| FCO VS40X-PA-F001, | Video streaking o | on VR160 & VF | R290 monitors. | |
| FIELD CHANGE ORDER | | Numk | ber VS40X-PA-F001 | |
| SYSTEMS AFFECTED: 3100 with the VS40 | - | | station 2000 and VAXs | station |

FIGURE 1: 8 PLANE COLOR MODULE (54-17282-01)

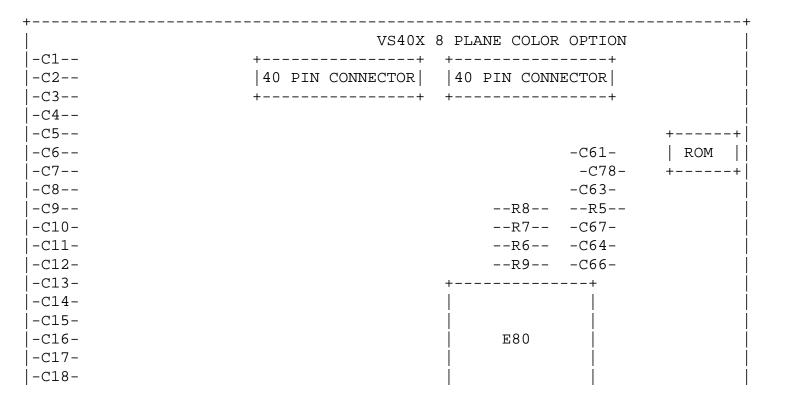
There may be a revision level stamped on the front of the module. Look at the far right side of the module and in the middle you will see the etch of the module. If it is C1, then the revision level should be B8 or higher and if the etch is D1 then the revision level should be B9 or higher. Any modules below these revision levels should be replaced.

If you can not find the revision level on the 8-plane module then place the 8-plane module on the static mat with the component side up, the two 40 pin connectors at the top furthest away from you, and the Digital logo on the bottom right. Starting from the bottom right side of the right 40 pin connector move down, check the third (C63), forth (C67), and the sixth (C66) capacitors. If they are glass type the module must be replaced. If they look like the 32 capacitors on the far left side of the module that go from top to bottom then the module has the ECO installed and does not have to be replaced. (See Figure 1 for more detail)

The old capacitors have a value of .01UF and the new capacitors have a value of .22UF.
